STATE OF MAINE
DEPARTMENT OF TRANSPORTATION
16 STATE HOUSE STATION
AUGUSTA, MAINE 04333-0016

January 19, 2023
Subject: Acadia Gateway
State WIN: 017163.03
Location: **Trenton**
Amendment No. 5

SHEET NUMBER
A602

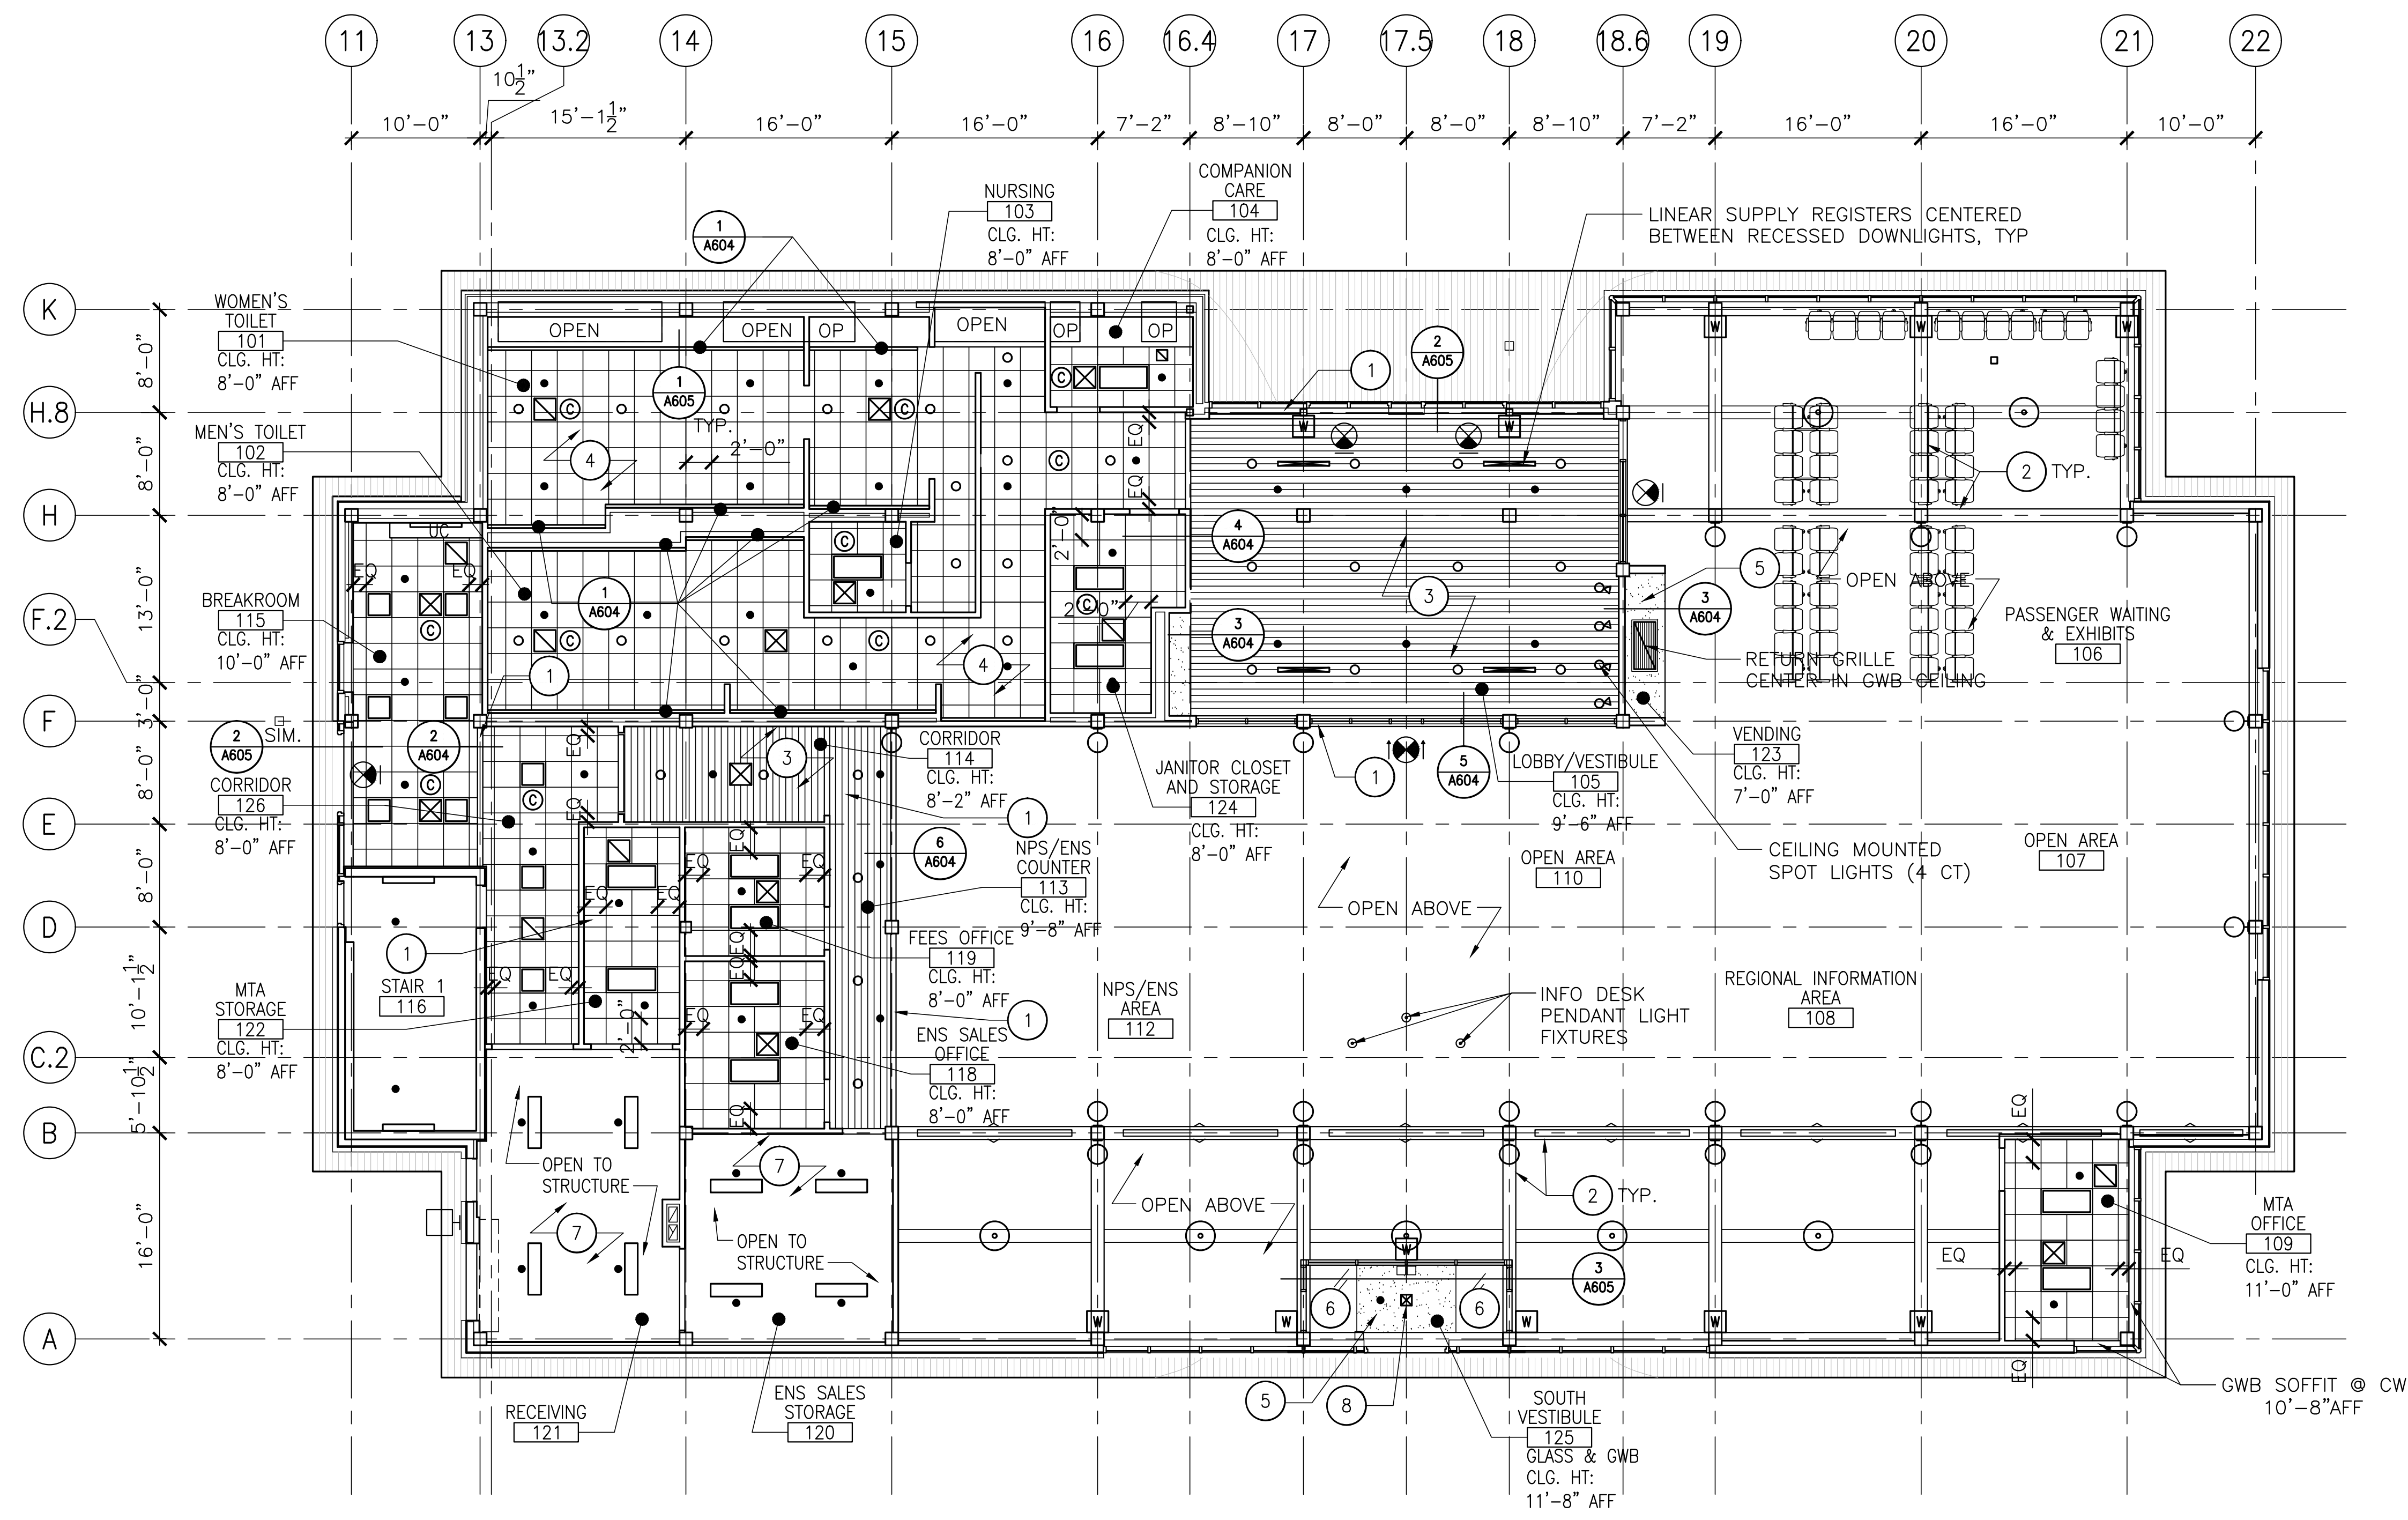
Question: On A602, Keynote 3 is "Wood Ceiling System". On A603, Keynote 3 is "Wood Ceiling". Please confirm that both Key Notes 3 are for WDC-1, Wood Slat Ceiling, as identified in the Finish Schedule on A614.

Response: A602 Keynote 3 refers to the WDC-1 finish. A603 Keynote 3 refers to the WDTG ceiling. Both A602 and A603 have been updated in Amendment #5 to clarify.

AMENDMENT 5 UPDATES:
 CLARIFIED KEYNOTE 3

4 ENLARGED COUNTER SWING GATE 2 PLAN
1/2"=1'-0"

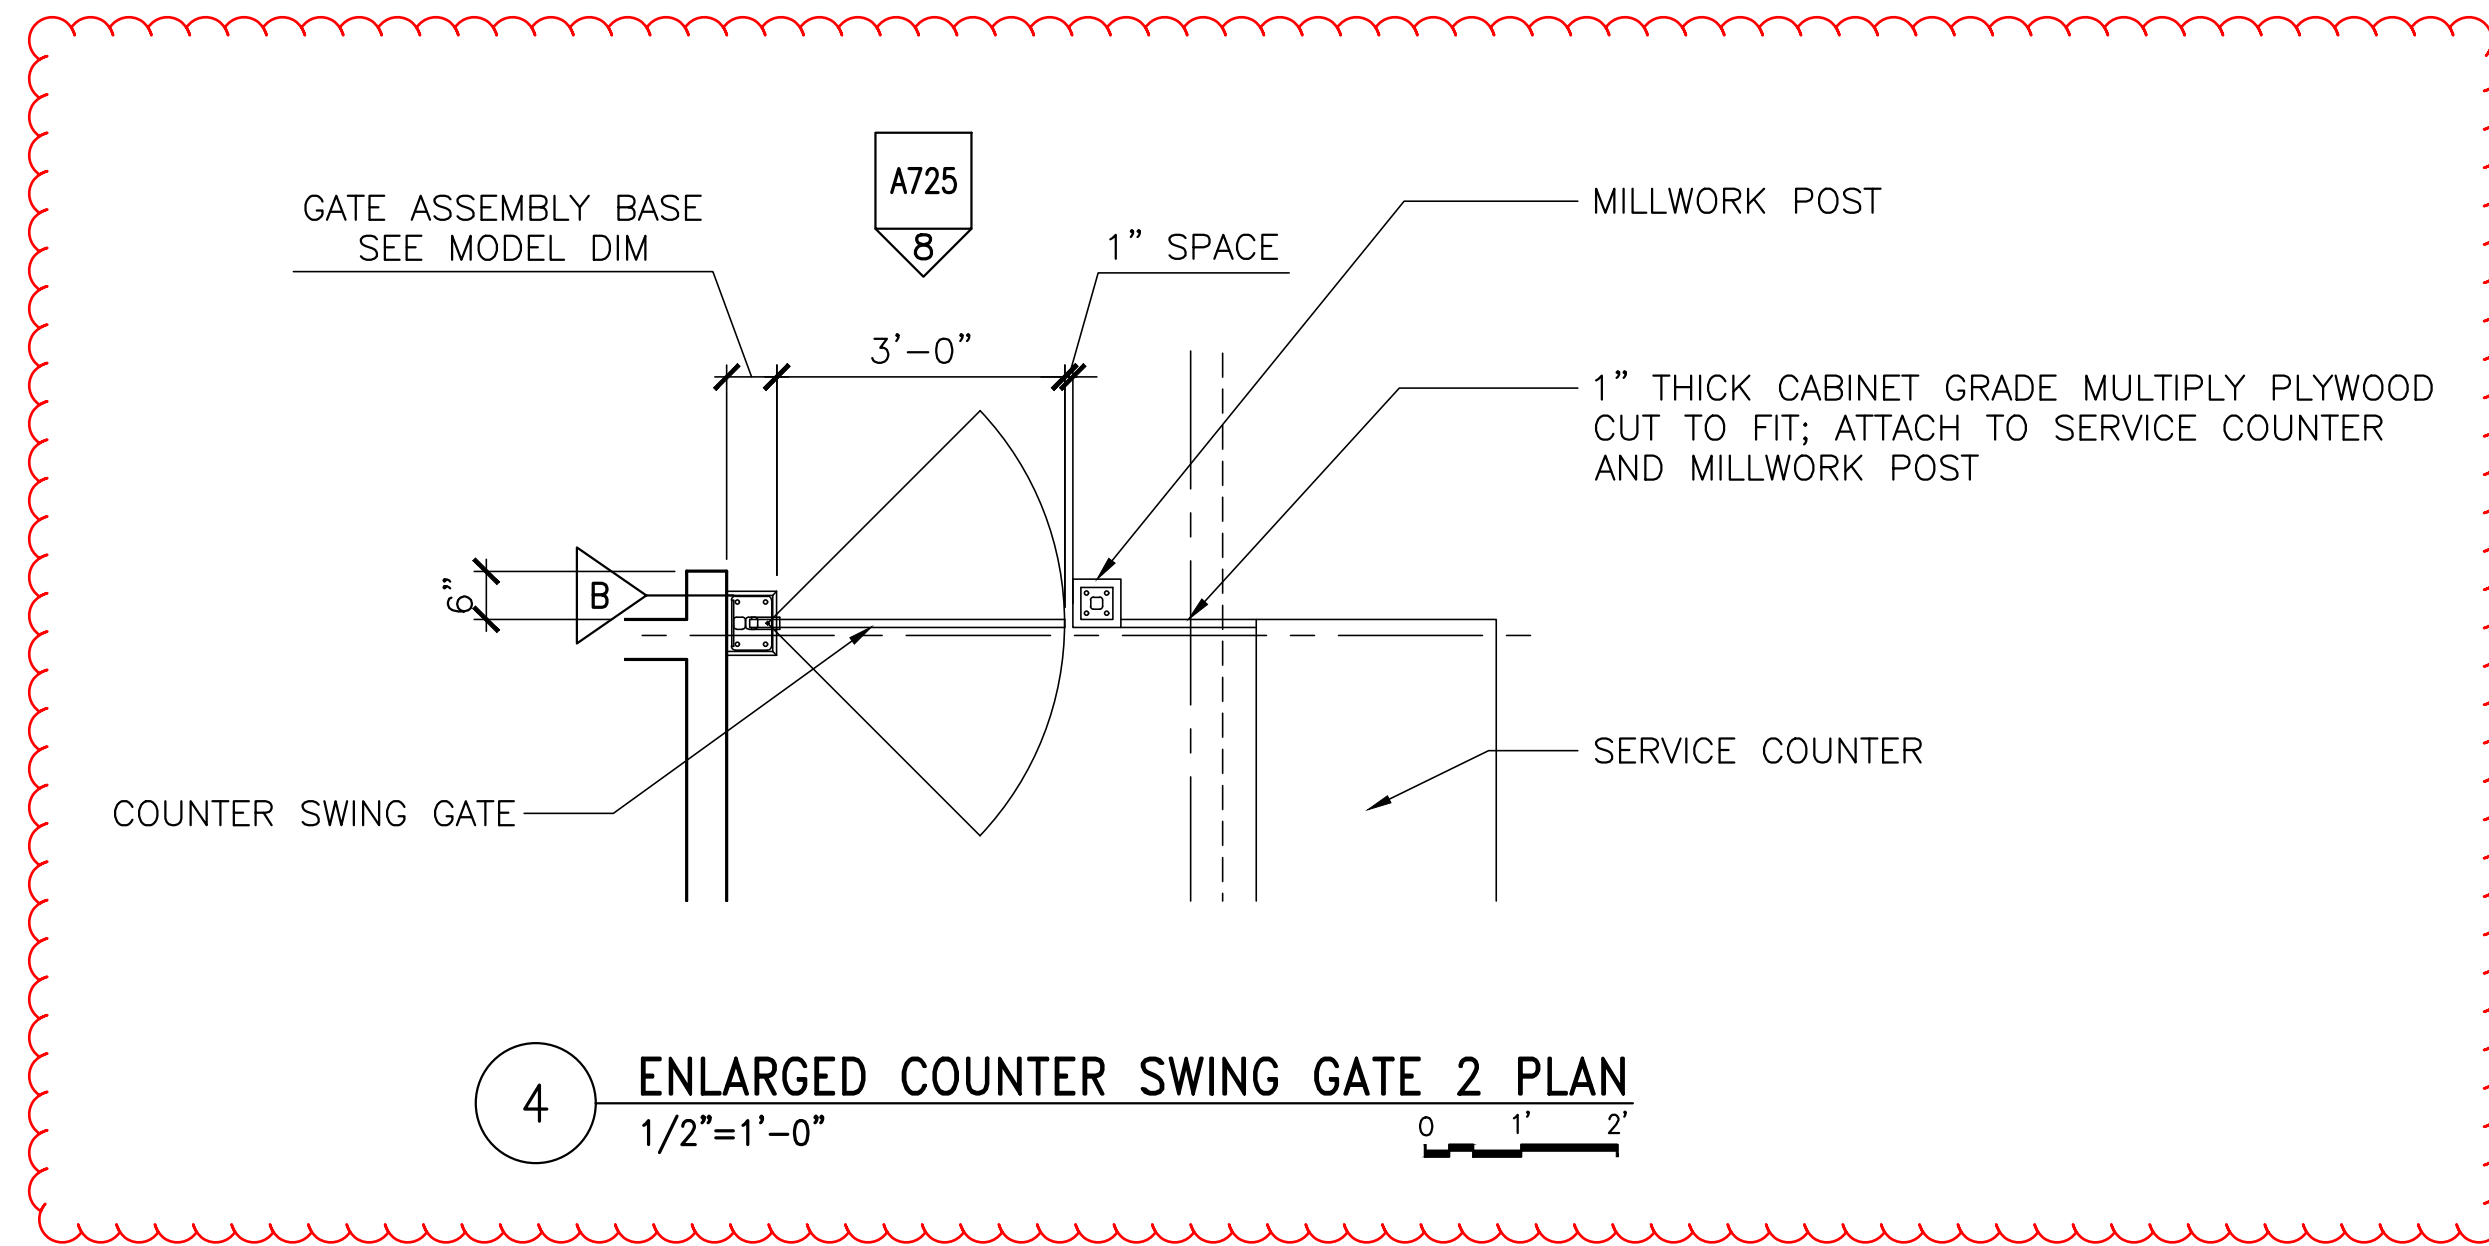
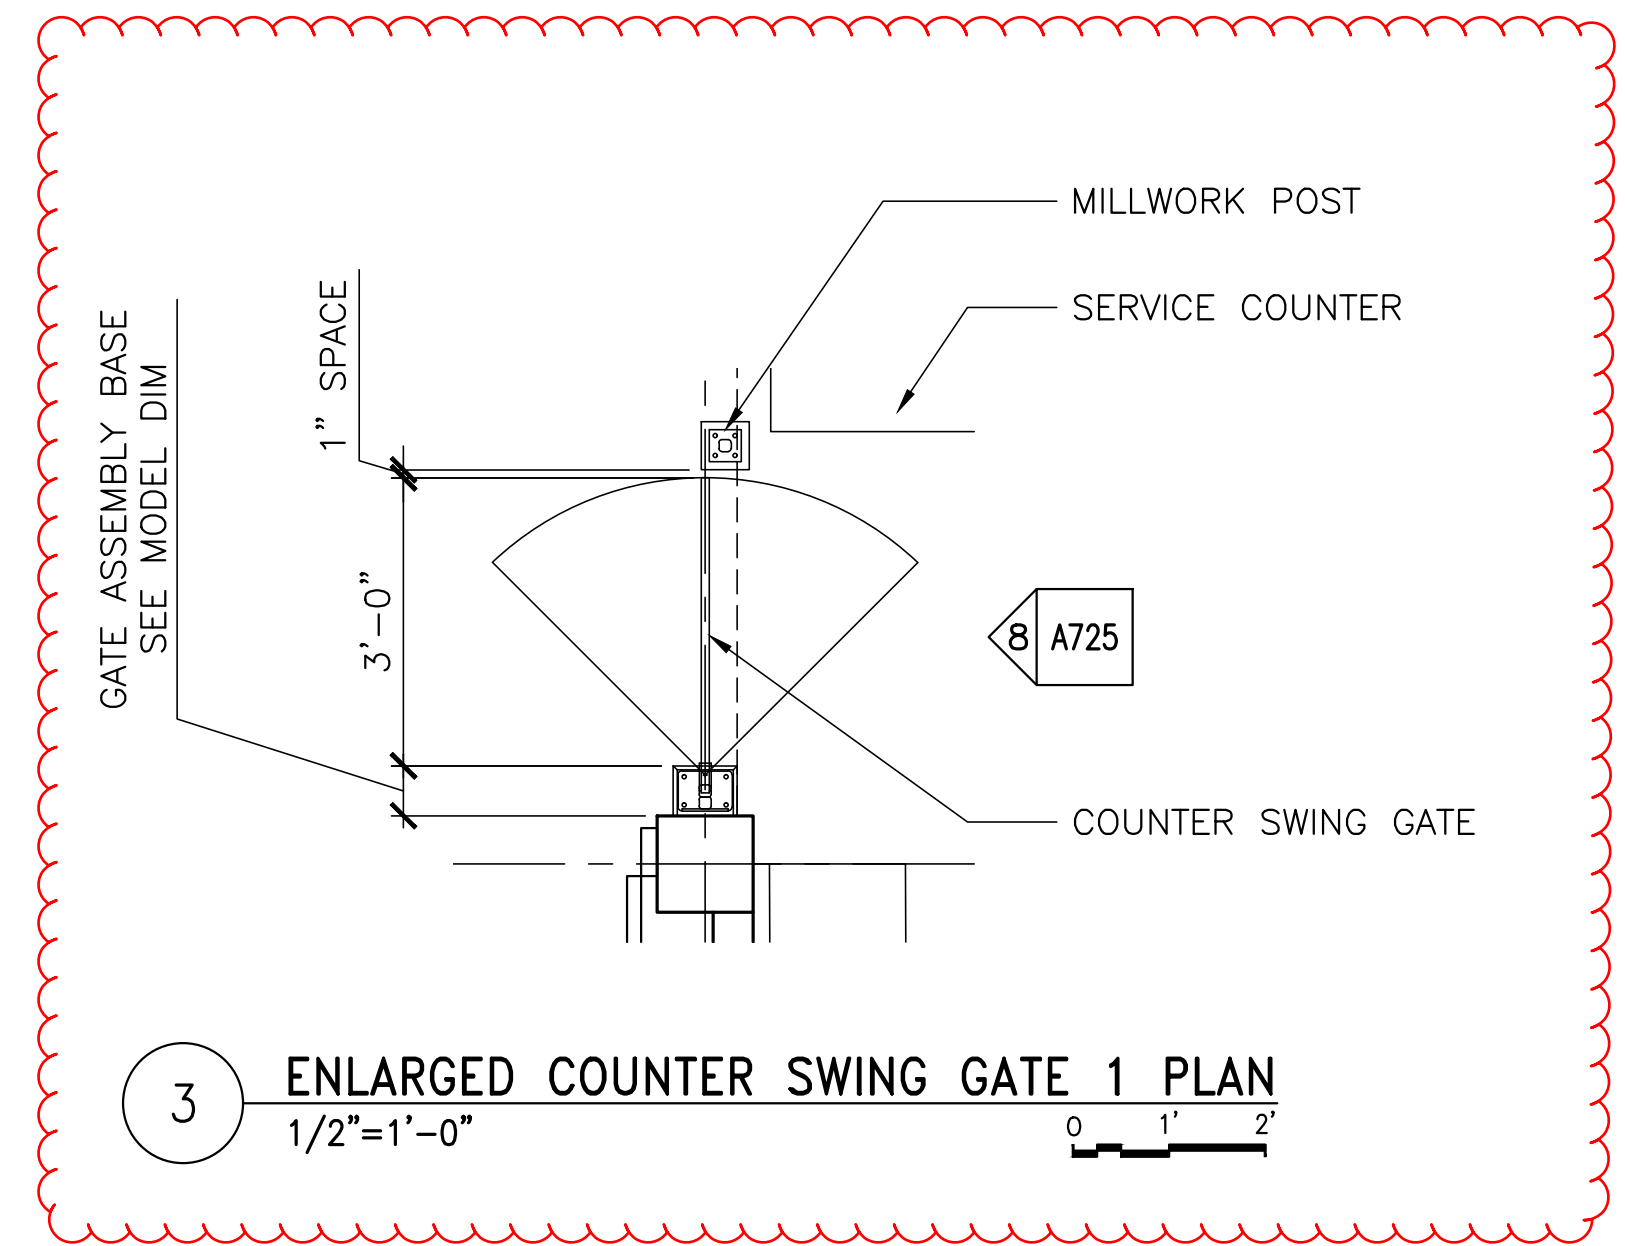
Question: There is a note about 2 counters/gates/panels at MW-03, Rm.#113 listed as TBD. Are details coming?

Response: Details for the two swing gates have been added to the drawings in Amendment #5. Sheets A202, A702, A703, A715, A721, A725 have been updated.
